PLANNING COMMISSION
DATE: 12/09/13
AGENDA ITEM: 4A – PUBLIC HEARING
CASE # 2013-29

ITEM: Boulder Ponds Planned Unit Development (PUD) – Concept Plan

To: Kyle Klatt, Planning Director
Cc: Nick Johnson, City Planner
From: Jack Griffin, P.E., City Engineer
Re: Bolder Ponds
Concept Plat Review

SHEET
Variations & Sections

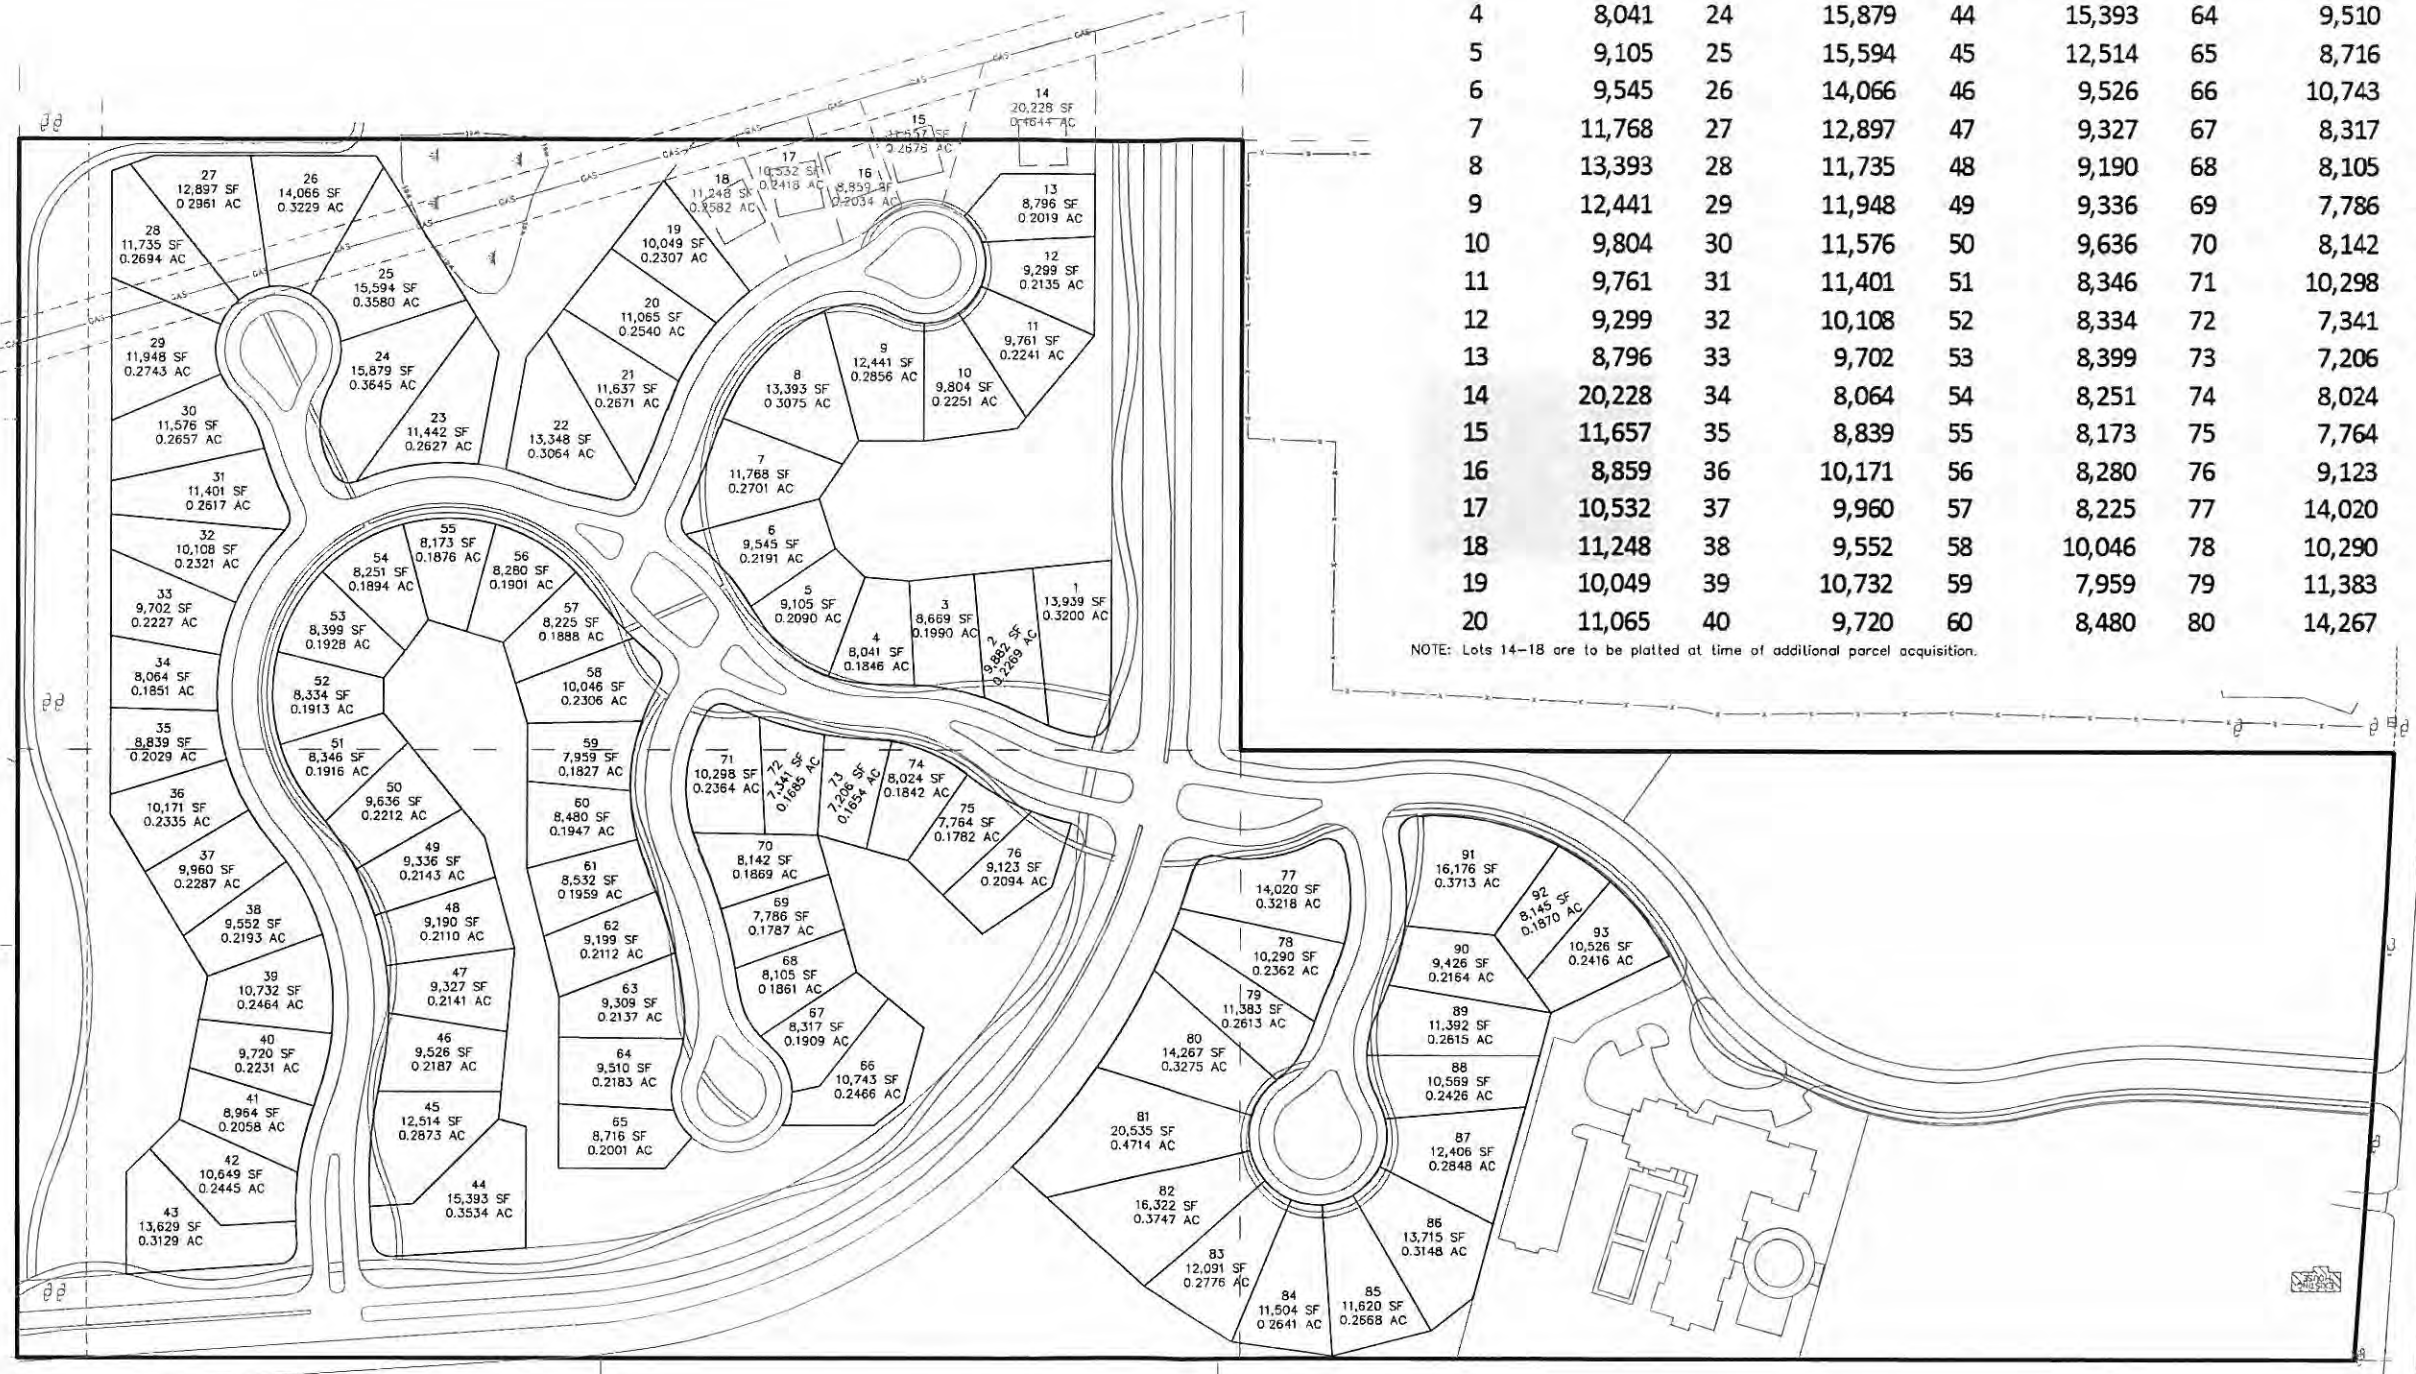
- The applicant is requesting a variance from the city street pavement section to ONLY require a 12-inch select granular subbase in areas with unsuitable in-situ materials. It is strongly recommended that all new city streets be constructed in strict accordance with the minimum engineering design standards manual to ensure that the city streets provide the intended useful service life of the asset. The purpose of the standard section requirements is to keep the asset from premature failure and avoid the cost burden that would fall upon the general tax payer of Lake Elmo.

- Side yard setback of 5 feet. Any allowance to deviate from the side yard setback should be conditioned upon proof of an acceptable drainage plan, with drainage NOT passing along that side of the structure.

SHEET
PUD Lot Areas

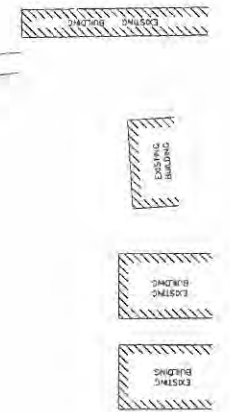
Also related to single family lots, the applicants have included five residential lots that are partially or almost entirely on a small triangular piece of property owned by Dale Properties. The applicants are proposing to acquire this land from Dale Properties in order to facilitate the platting of these five additional lots and realign the minor collector road to the south. Dale Properties has submitted a letter (Attachment #5) indicating that general agreement has been reached on the land acquisition. For the purposes of the Concept Plan, the applicants have "ghost platted" the five lots, Lots 14-18 on the PUD Lot Areas sheet, with the intention of acquiring the land prior to Preliminary Plat submission. If these lots are to be included in the PUD Preliminary Plan and Preliminary Plat, the applicants must submit evidence demonstrating control or consent of this area being included in the plat. If this is not possible, plans must be revised accordingly.

- 4) The applicant must acquire additional land in the eastern portion of the site to plat single family residential Lots 14-18 as part of the Preliminary Plat application, or revise their plan accordingly.
